Access Compliance Report

Public Rights-of-Way

Intersection ID: 29758	Main Street: BALLANTYNE_COMMONS_PY	Cross Street: WILLIAMS_POND_LN	Location: SW
ADA ID: 1CF26D7826BB	Ramp Type: Perp	Initial Pass/Fail: Fail	Overall Compliance: No
Severity Score: 22.5			
Codes/Mitigation Info/Possible Solution		Field Measurements/Component Compliance

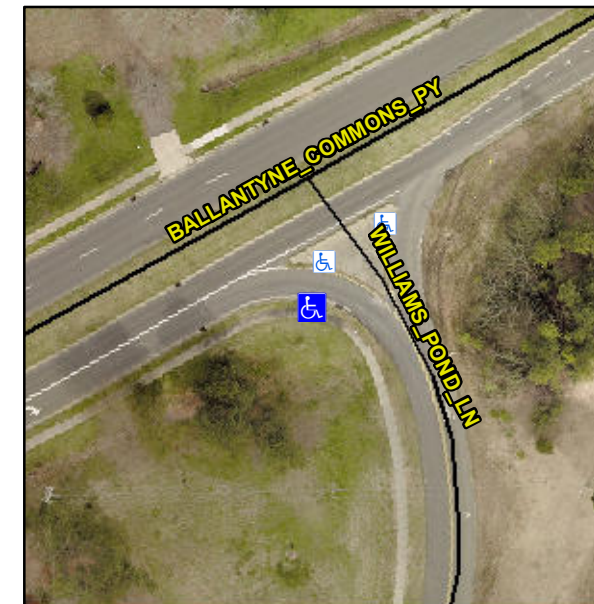
Not Found, R304.5.1, R304.2.2, R304.5.3

Compliance	Description	Data	Compliance	Description	Data
N/A	Ramp Length (in)	109.0	No	Ramp Slope (%)	8.8
No	Ramp Width (in)	41.5	No	Ramp XSlope (%)	4.7
N/A	Flare Type LT	N/A	N/A	Flare Type RT	N/A
N/A	Flare Slope LT (%)	N/A	N/A	Flare Slope RT (%)	N/A
N/A	Flare Traversable LT?	N/A	N/A	Flare Traversable RT?	N/A
N/A	Landing Length (in)	N/A	N/A	DWS Provided?	N/A
N/A	Landing Width (in)	N/A	N/A	DWS Contrast?	N/A
N/A	Landing Slope (%)	N/A	N/A	DWS Length (in)	N/A
N/A	Landing X Slope (%)	N/A	N/A	DWS Full Width?	N/A
N/A	Landing Curb? (Y/N)	N/A	N/A	DWS Offset (in)	N/A
N/A	Shared Landing?	N/A			
N/A	Gutter Ponding?	N/A	N/A	Gutter Slope (%)	N/A
N/A	Gutter Lip Ht (in)	N/A	N/A	Gutter X Slope (%)	N/A
N/A	Painted X Walk1?	No	N/A	Painted X Walk2?	N/A
	X Walk 1 Direction	To NE		X Walk 2 Direction	N/A
N/A	X Walk 1 Width (in)	N/A	N/A	X Walk 2 Width (in)	N/A
	X Walk 1 Slope (%)	0.8		X Walk 2 Slope (%)	N/A
	X Walk 1 X Slope (%)	2.8		X Walk 2 X Slope (%)	N/A

Remove & Replace Entire Ramp.
